Updates to Scheduled Traffic State Machines to Support 802.1Qbu Frame Preemption

- Supplement for P802.1Q-rev D2.1 comments -

IEEE 802.1 Interim Meeting, Jan. 2018
Geneva, Switzerland

Figure 8-16—List Execute state machine

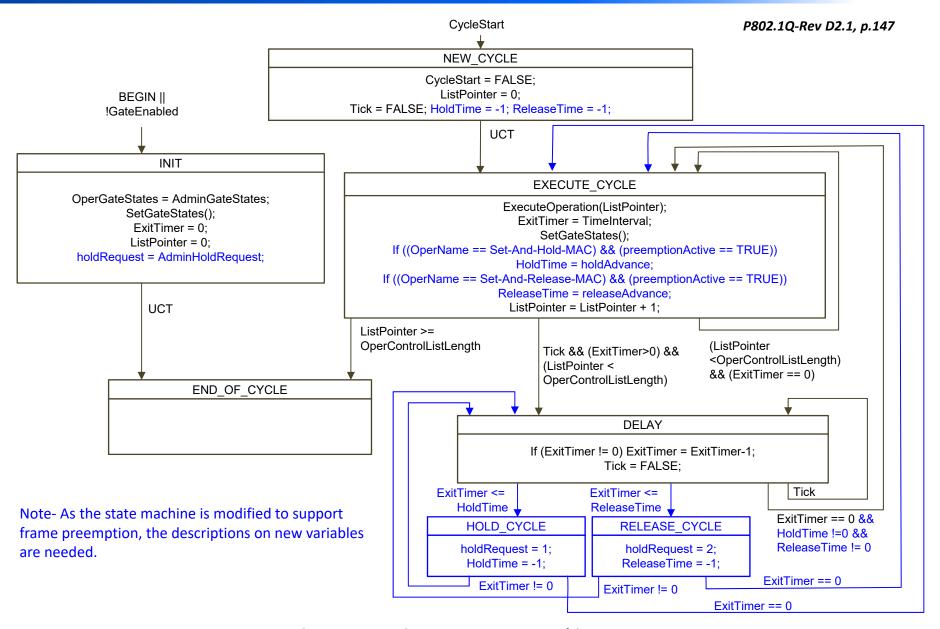
We think that option A is correct based on existing text in 802.1Q and our observation given below.

- The hold or release signal is generated when the holdRequest managed object value changes.
- The holdRequest managed object value is changed when the Set-And-Hold-MAC or Set-And-Release-MAC gate operation has been executed.

Proposed modifications for Option A

Figure 8-16—List Execute state machine

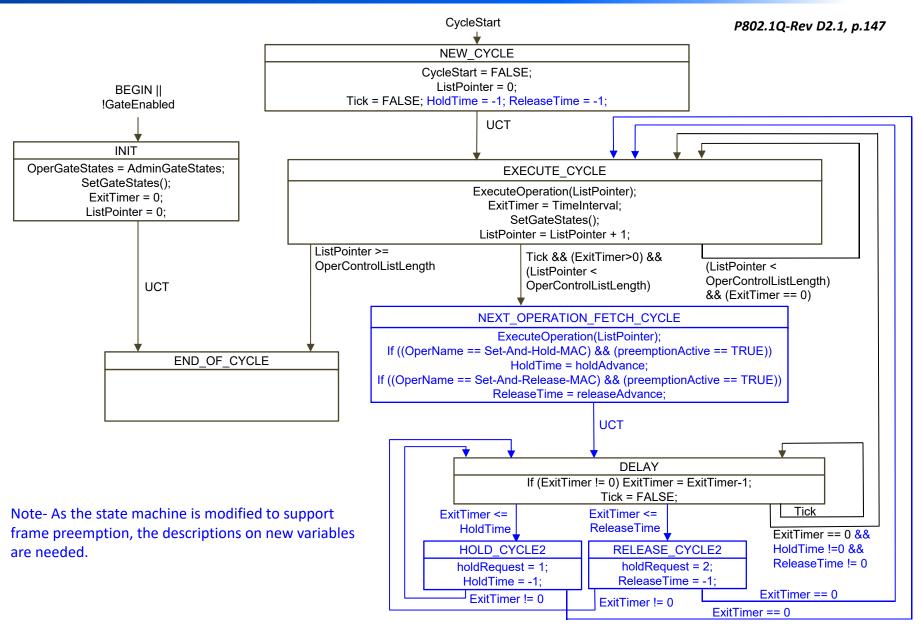
- It is not obvious how management/administrator can (pre)configure the time instances of issuing the hold or release signals.
- 802.1Q needs to describe
 - how to determine the time instance of issuing the hold or release signal, and
 - how to make the operation name aligned with the hold/release status effective at that time slot.
- The following modifications can be done to 802.1Q:
 - Modify the corresponding state machines.
 - Change the definition of the holdRequest managed object.
 - * See the next slides for the required modifications.

Required modifications for option B (1/3)

Figure 8-15—Cycle Timer state machine

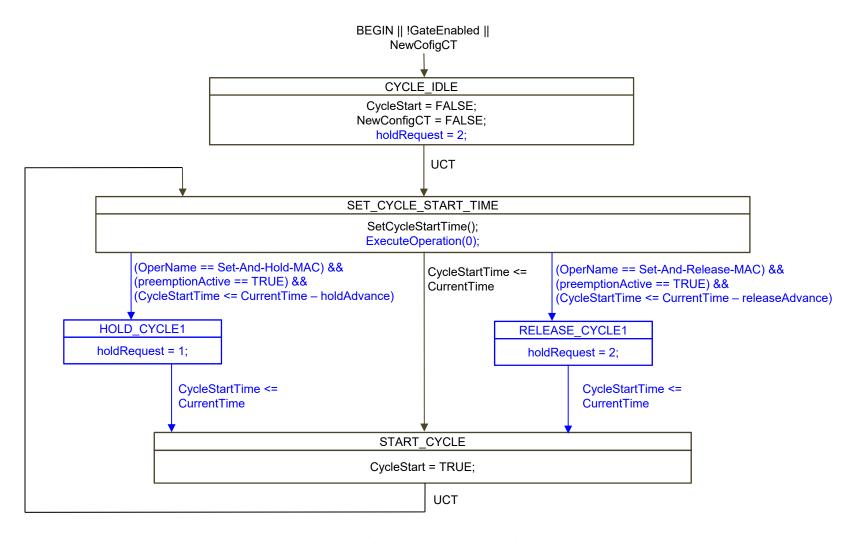
Required modifications for option B (2/3)

P802.1Q-Rev D2.1, p.145
